RC Transponder

REVISION 1.10

| Title CPU | | | |

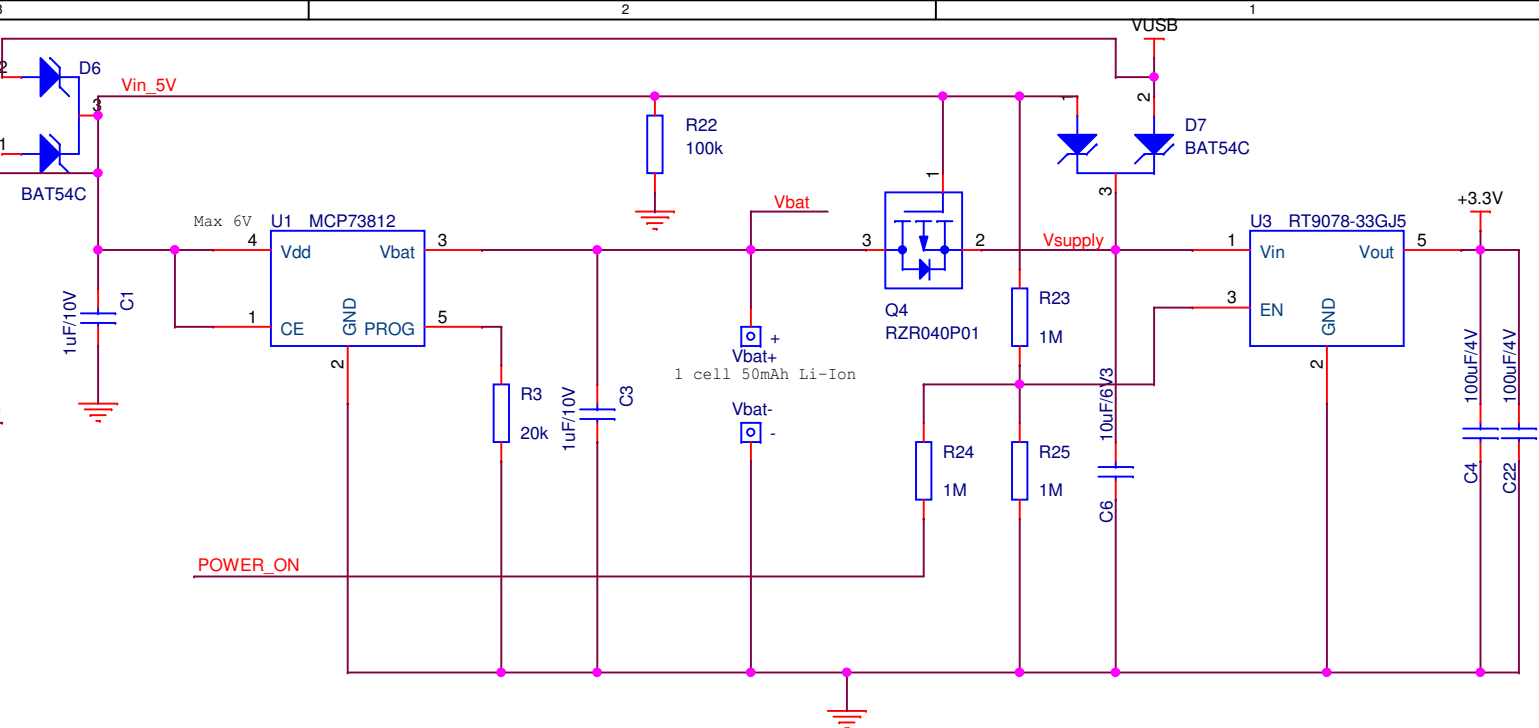
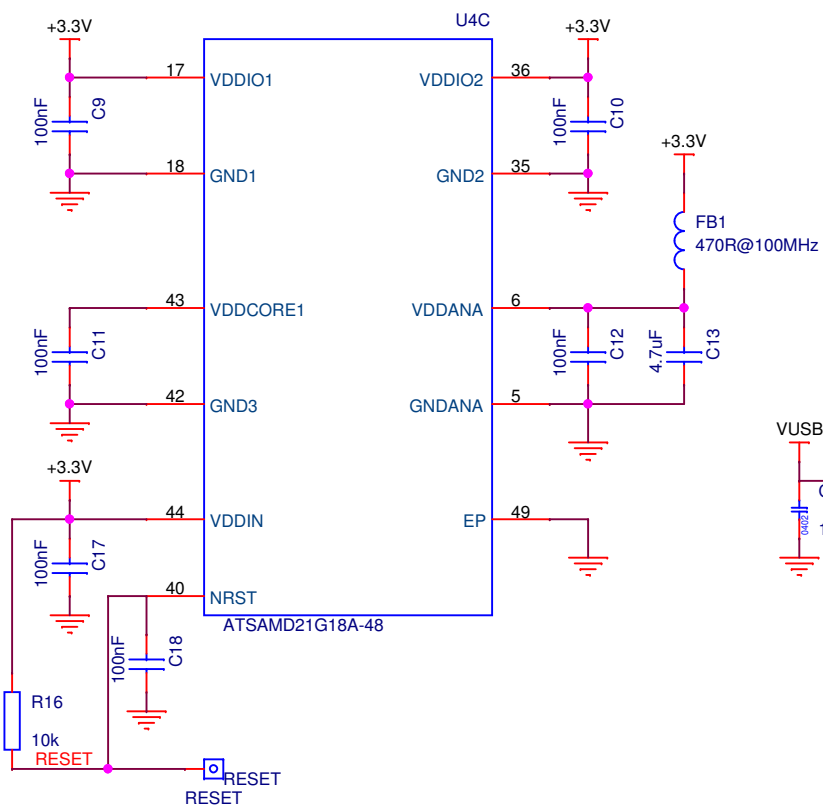
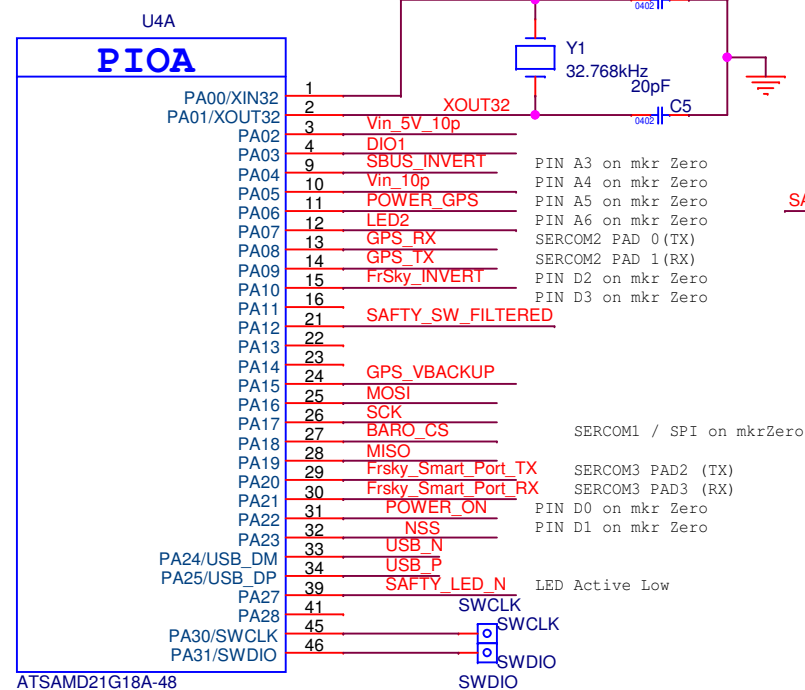
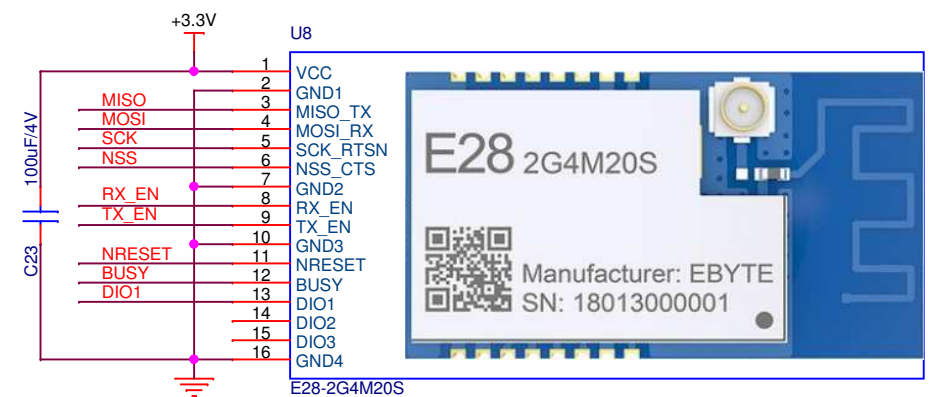
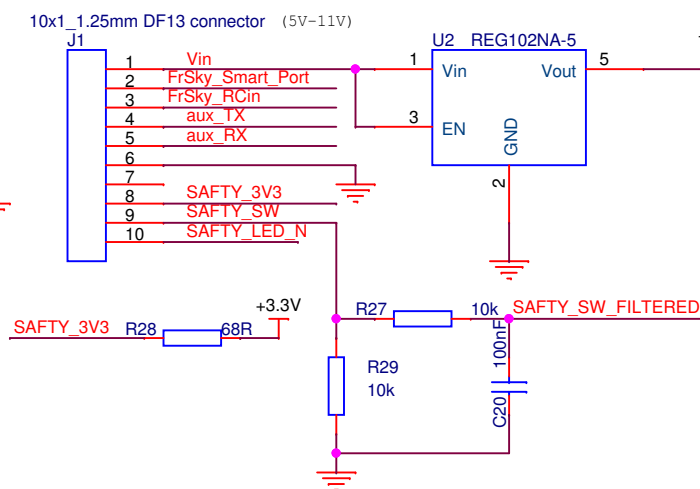
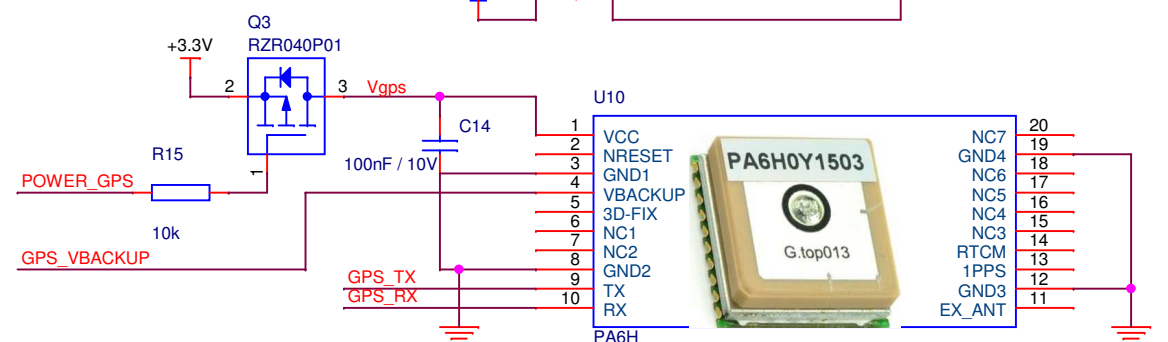
| Revision | History | Responsible |
|----------|---|----------------------|
| 1.10 | DF13 connecter changed to 10pin version to support safety switch. PSU redesigned for low-power and to supply power around the Li-ion charger. Vin_5V added to CPU ADC, so CPU can detect if it is powered from Vin or USB. Support for safety switch added and LED1 removed. MS5611 pressure sensor added. DIO1 added to CPU. U6 and U7 XOR gates are now powered from Vgps so CPU can turn off power to them. R26 added to avoid noise on input when RCin is not connected in DF13. C23 added for radio. | Kenneth Lagoni Olsen |
